Groundwater Application Review Summary Form

Application # G- 19177

PUBLIC INTEREST REVIEW FOR GROUNDWATER APPLICATIONS

TO: Water Rights Section Date 2/27/2024
FROM: Groundwater Section Stacey Garrison/Travis Brown
SUBJECT: Application G- 19177 Supersedes review of

Water-Level Measurements in MARI 308

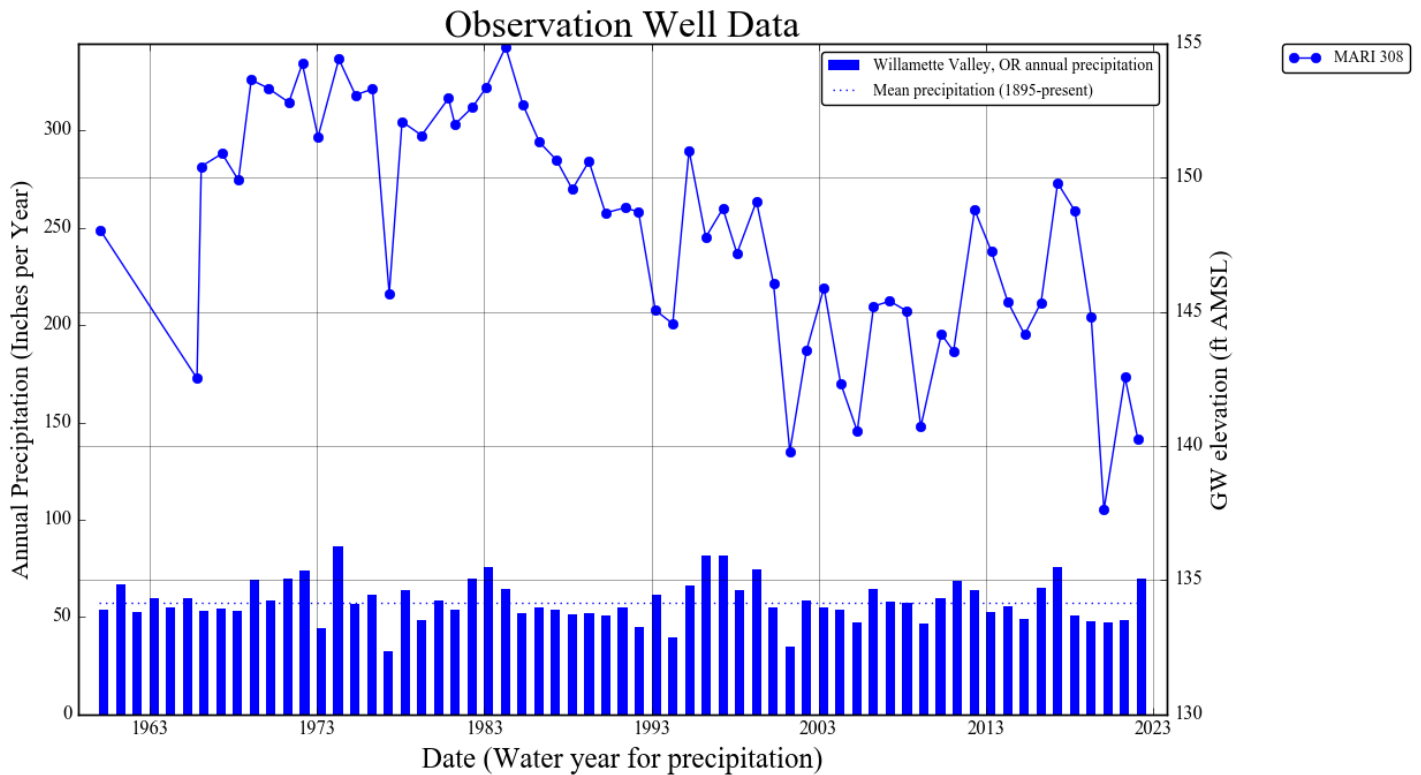
Water level trends for nearby (1 to 3 miles from POA) wells that utilize alluvial aquifers appear to be declining (see **Water Level Measurements in Nearby Wells**). Seven of the eleven wells included have experienced water level declines ranging from 3 to 7 ft over the last 10 years (CLAC 62437, MARI 308, MARI 365, MARI 51133, MARI 53448, MARI 59123, MARI 60579). The remaining 4 wells appear to have steady water levels. MARI 308 is part of the Department’s long-term monitoring network, and the measurements demonstrate that the decline has been occurring for some time (see **Water Level Measurements MARI 308**). There are 32 groundwater POAs for 36 water rights within 1 mile of Well 1, and nearly all utilize the alluvial aquifer. While there are steady declines, there is not a preponderance of evidence to support that the water levels in the alluvial groundwater reservoir are declined excessively or excessively declining; therefore, the groundwater reservoir is not over-appropriated.
